Technical change to the WSI 6

1. Initial situation

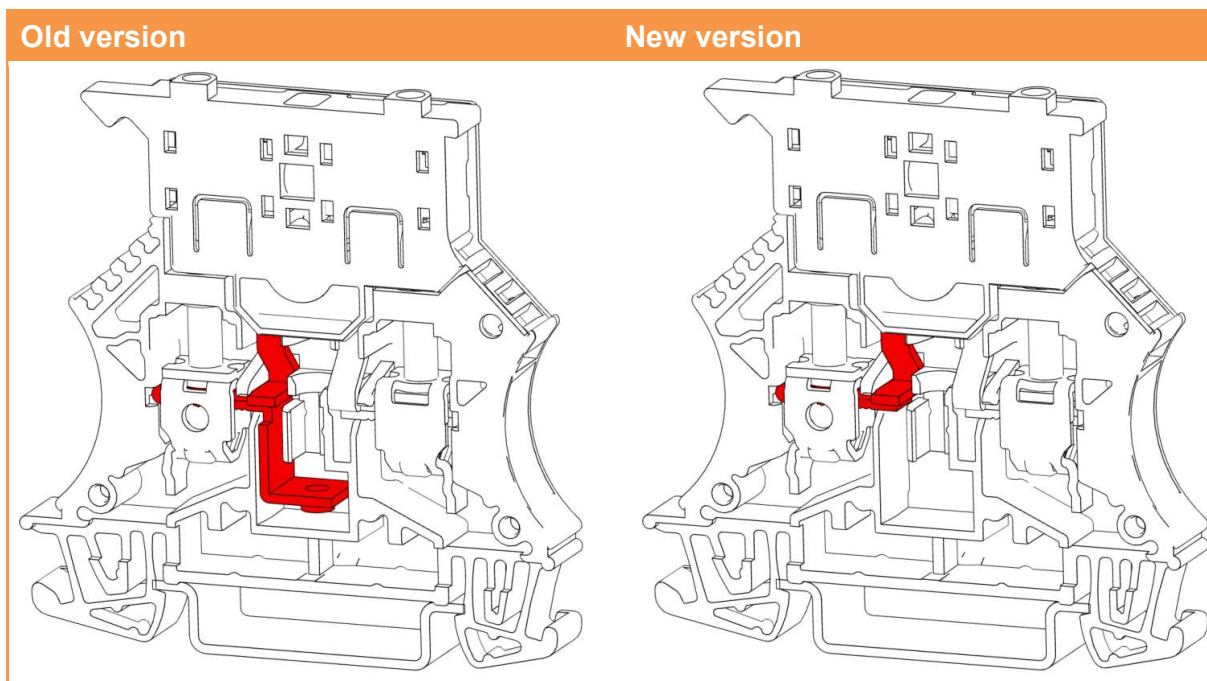
The left current bar of the WSI 6 has an extension which allows to set a cross connection between adjacent WSI 6 terminals. The cross-connection option is very time-consuming to assemble and is no longer common in the market:

The moulding of the WSI 6 has a breaking point that must be removed first. Then the cross-connection bar must be pushed through the terminal blocks from the side. After that the cross connection must be screwed to each of the WSI 6 terminals from above. This is very time consuming and susceptible for doing mistakes.

The left current bar of the WSI 6 will be shortened. Thereby it's not possible to mount a cross connection anymore.

This type of cross-connection is no longer common in the market, which means that this type of cross-connection is no longer used by our customers.

We therefore remove this feature, which customers no longer demand, and thus optimise our portfolio.
